RE: 17TH STREET CANAL PARALLEL FLOOD PROTECTION
PHASE 1B - HAMMOND HIGHWAY TO SOUTHERN RAILWAY
OLB PROJECT NO. 2043-0207

In your letter of October 21, 1988, you listed comments on our preliminary plans for the above referenced project. In our review of those comments, we discovered that the slope stability calculations for the first six reaches of this project do not properly reflect the actual factors of safety.

We are submitting revised slope stability and sheet pile analyses for Reaches 1 through 6 which supersede the previously submitted calculations and consequently make obsolete comments "a" and "b" of your letter of October 21, 1988.

REACH 5
STA. 625+00 TO STA. 635+00

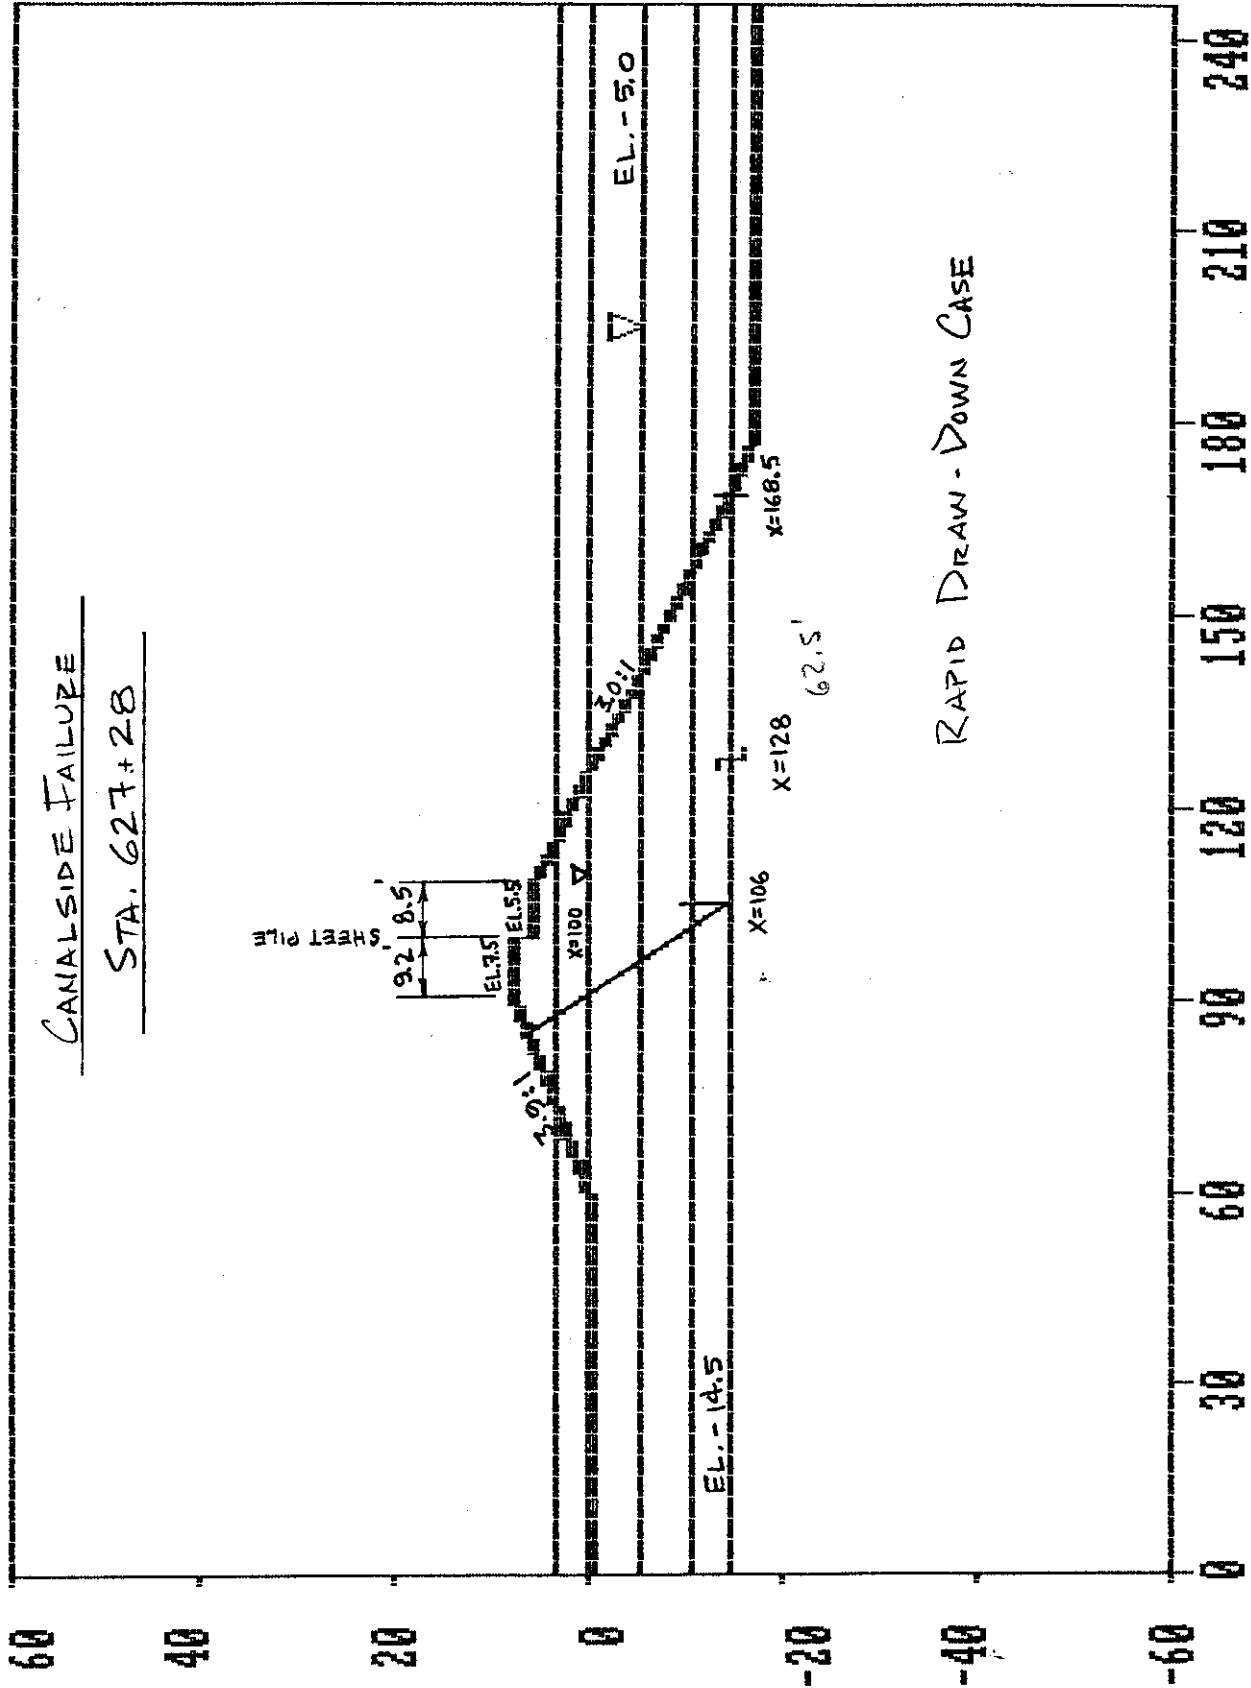
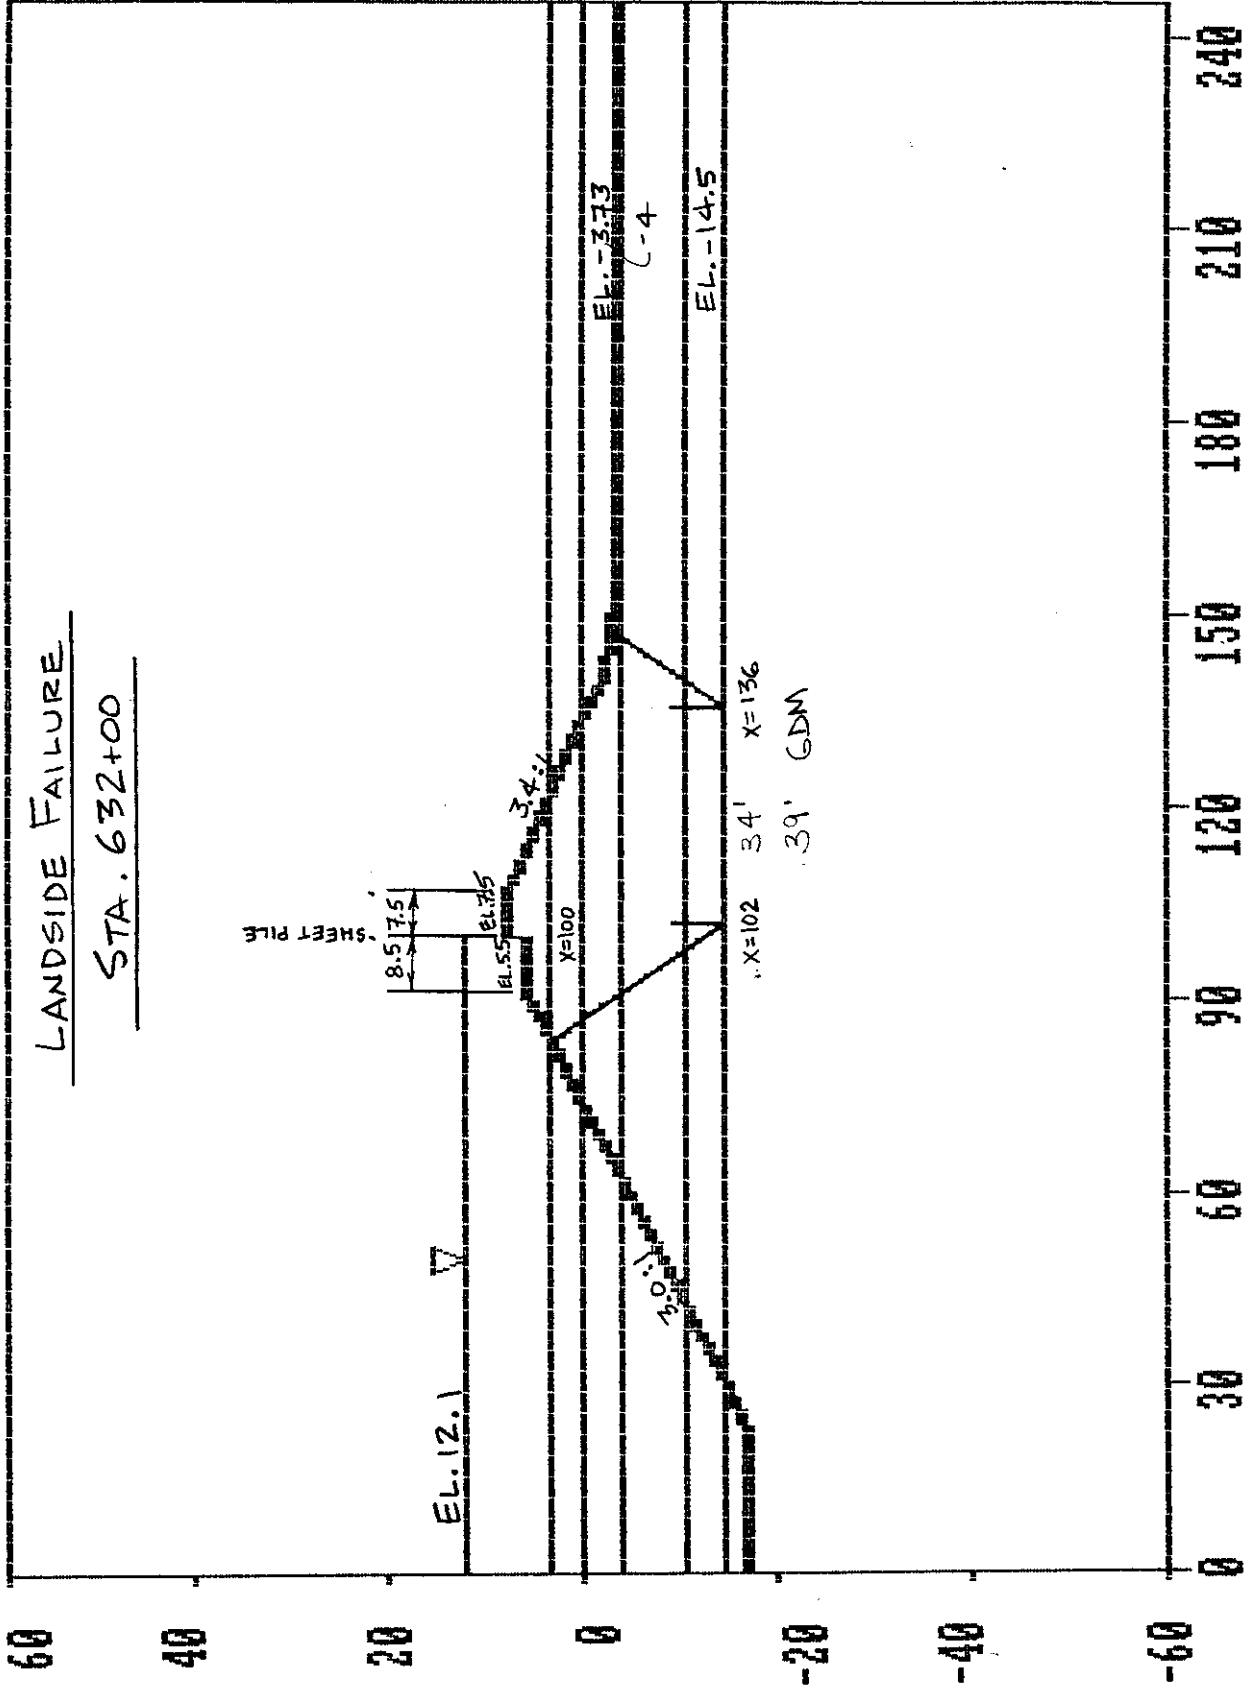
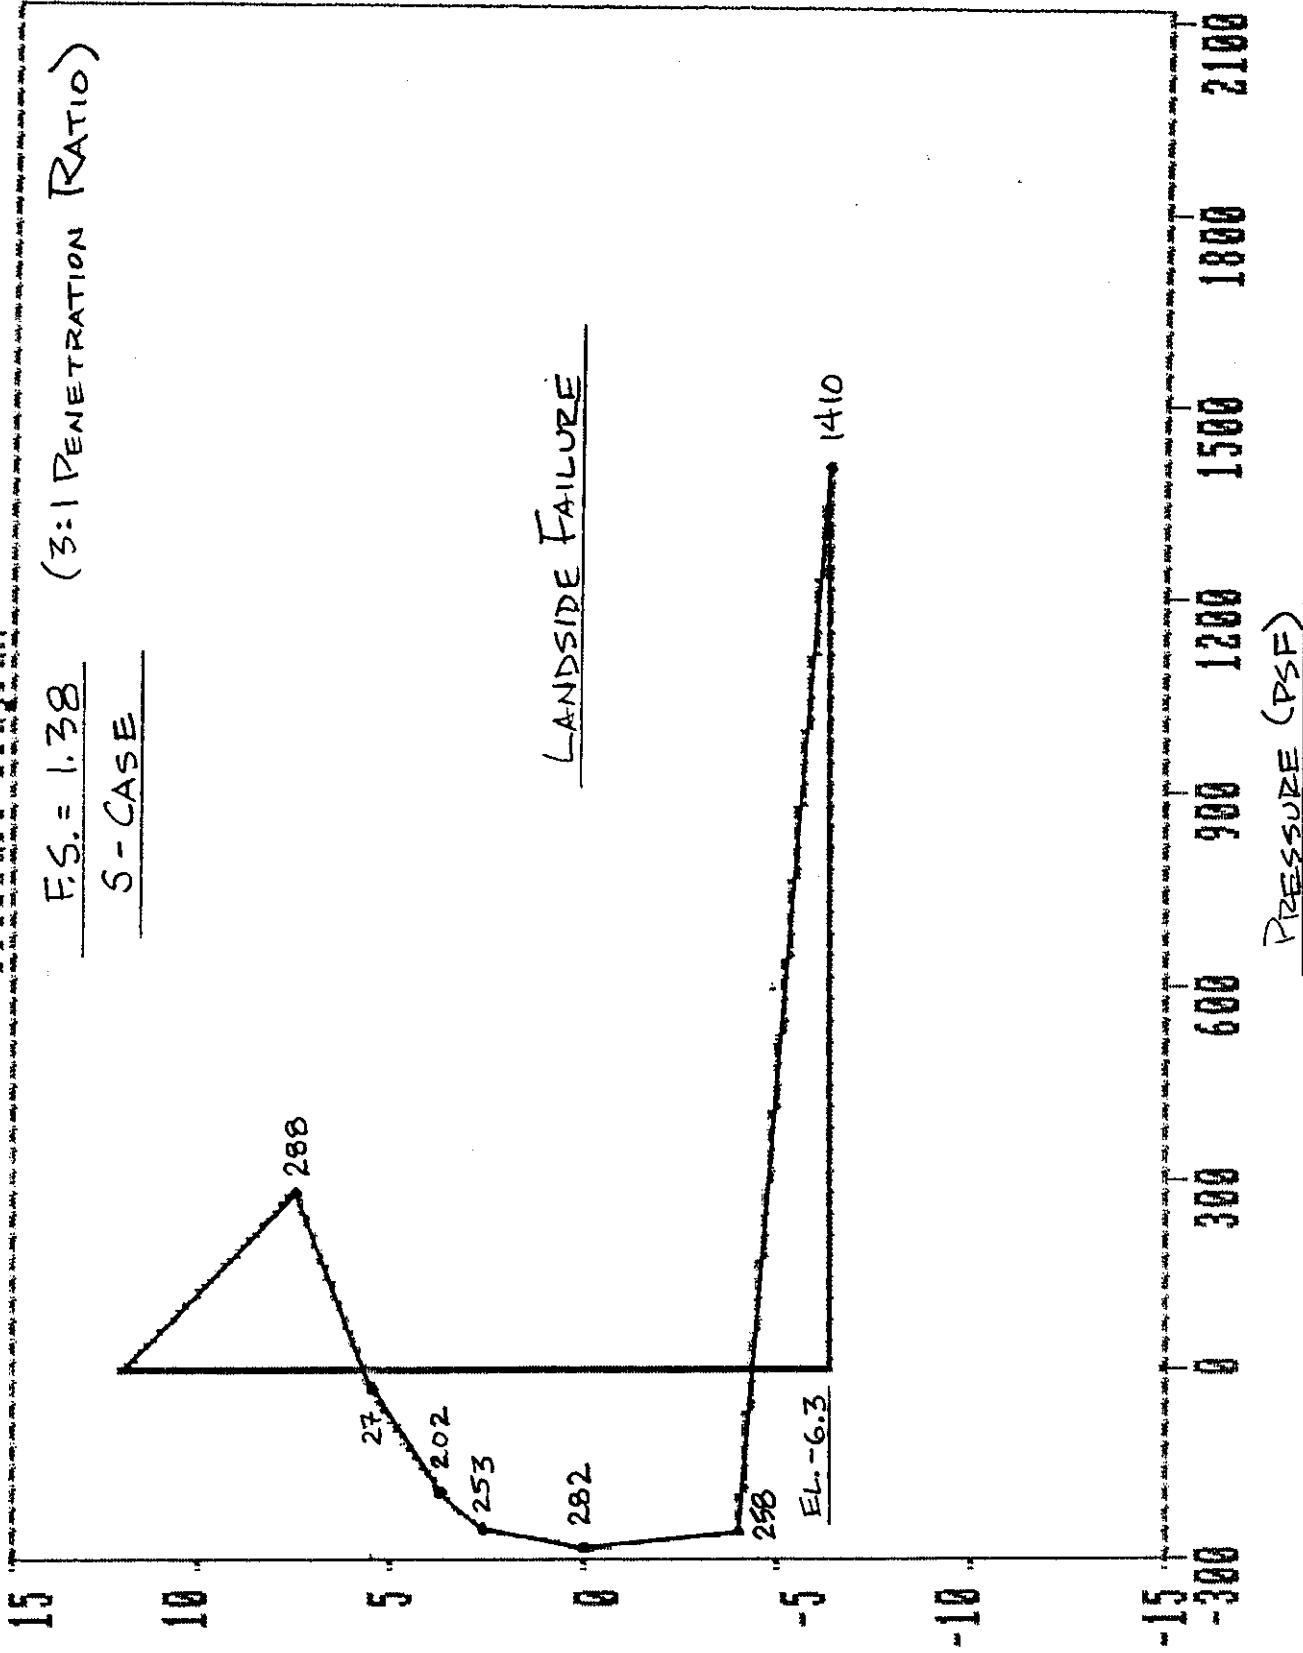
Revisions to Cross-Section : Realign Sheet Pile
Raise Step Elevation to 5.5 and Decrease Width to 8.5'

crowm = 10.9' width
New sheetpile = -2.4' Protected side
8.5' say 10x3 gives 5.5 crown width
but can slope to point on levee slope to get 6.5 width with 1:3 slope
@ 8.5' Elev = 6.57

GDM Uses EL - 4.9 Tip. GDM has I-wall crown width @ 6.5' vs. 6.2' and has flatter back side levee slope.
Using same ground profile as Sta 634 Tip EL -5.45

Strength Line
 Eustis Report
 Shows 500 PSF
 to EL -2.0 NOT
 EL 0.0

- Canalside Failure - 627+28.
*** Minimum Factor of Safety = 1.30 *** (Rapid Draw-Down Case)
- Landside Failure - 632+00 and 634+00. The section at Sta. 632+00 governs.
*** Minimum Factor of Safety = 1.31 ***

Required Penetration : -6.3 (Landside Failure 3:1 Ratio; S-Case F.S.=1.38)
Design Bending Moment : 5.3 Ft-K/Ft @ El. 0.8 (Landside Failure 3:1 Ratio; S-Case F.S.=1.38)
Maximum Deflection : In.

REACH 6
STA. 635+00 TO STA. 643+00

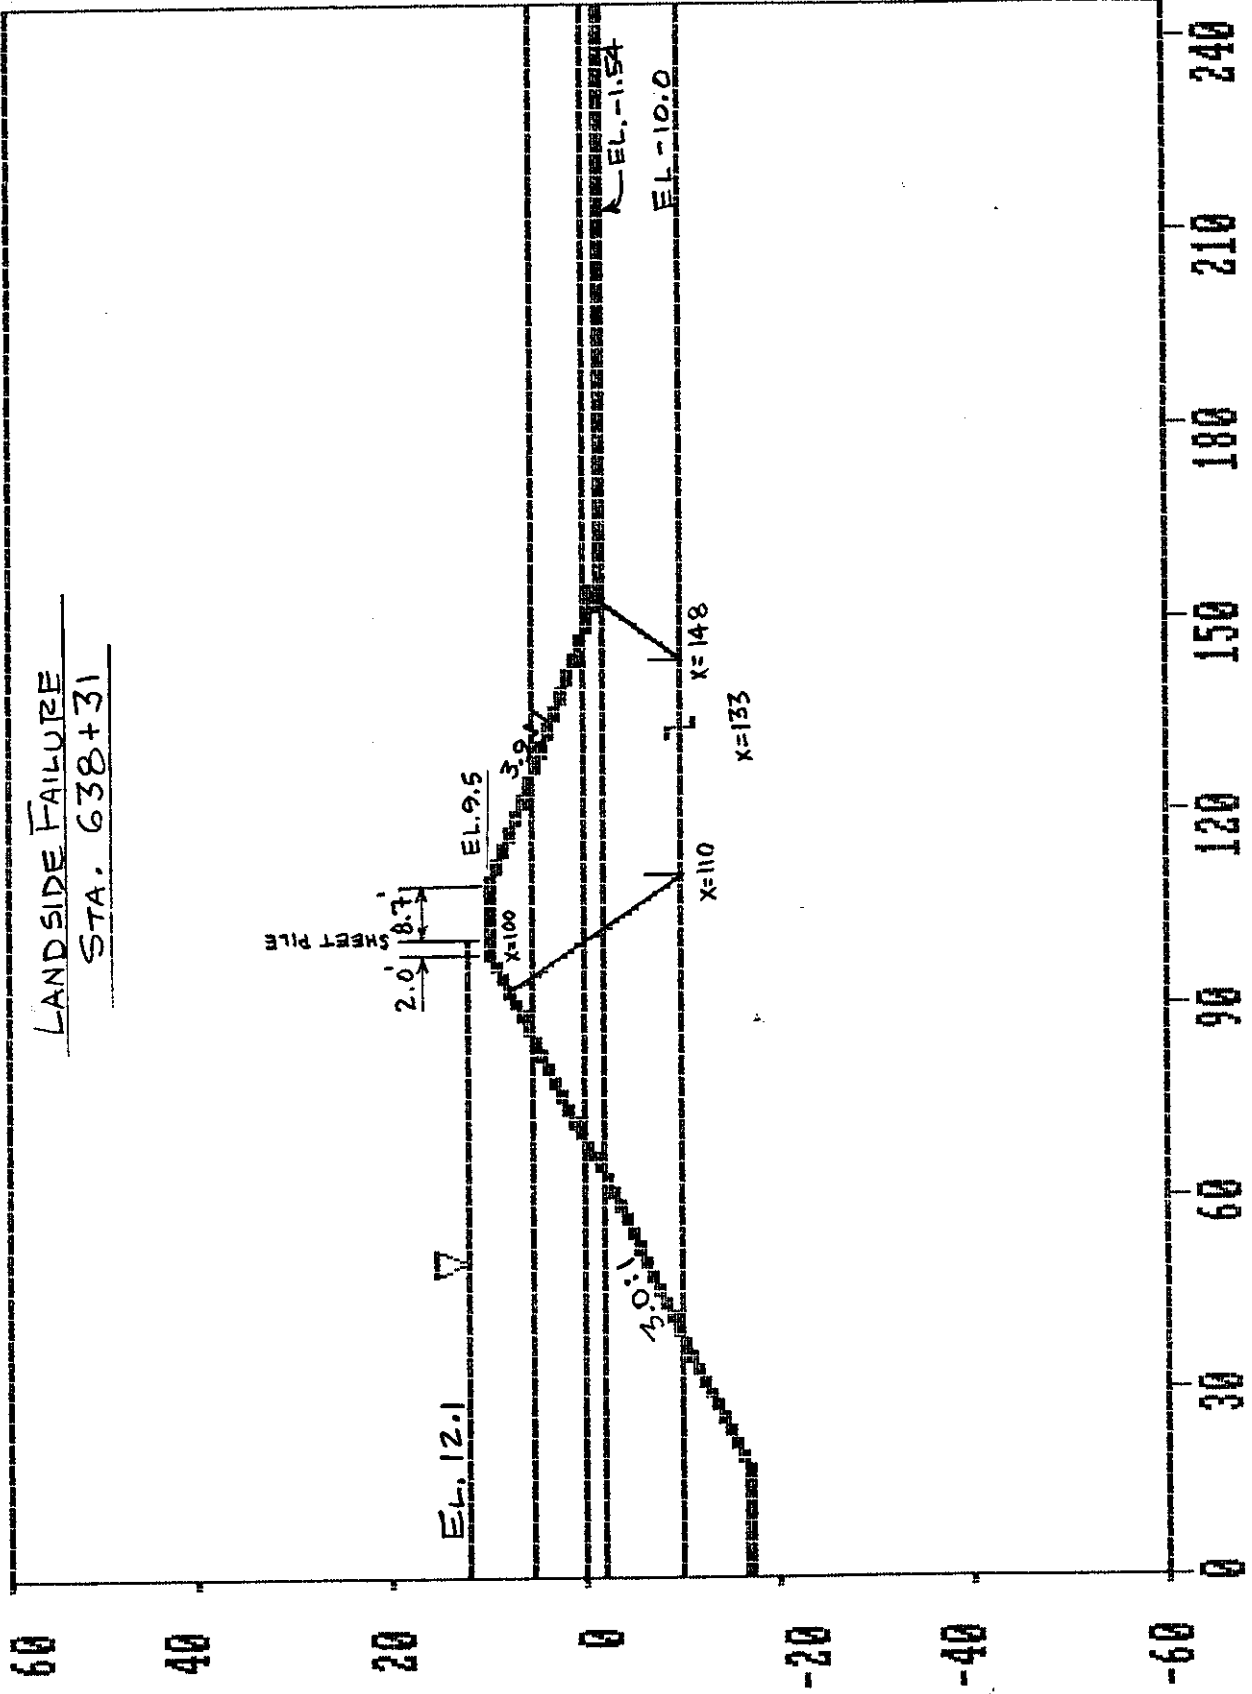
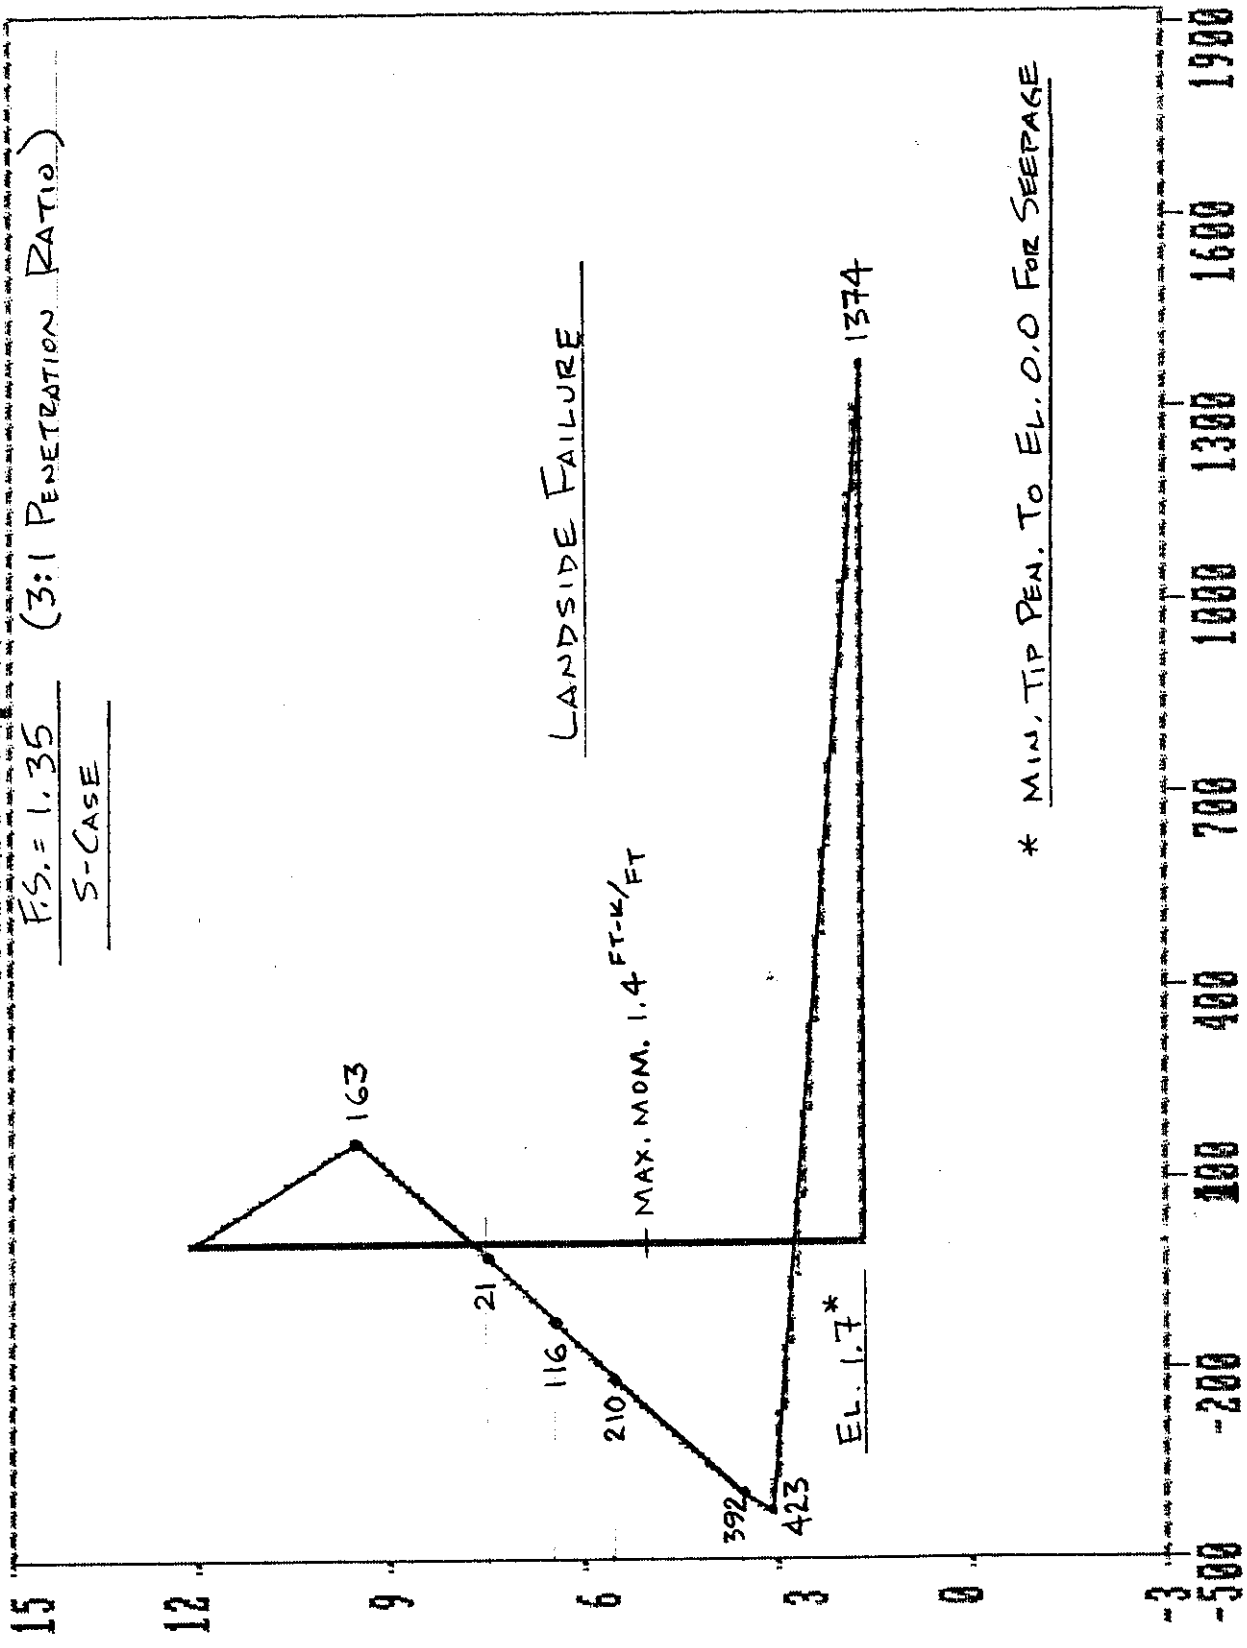
Revisions to Cross-Section : Realign Sheet Pile

OK SAME AS GDM

Canalside Failure - The section at Sta. 638+31 governs.
*** Minimum Factor of Safety = 1.48 *** (Rapid Draw-Down Case)

Landside Failure - The section at Sta. 638+31 governs.
*** Minimum Factor of Safety = 2.05 ***

Required Penetration : 0.0 (Governed by Seepage)
Design Bending Moment : 1.4 Ft-K/Ft @ El. 5.0 (Landside Failure 3:1 Ratio; S-Case F.S.=1.35)
Maximum Deflection :
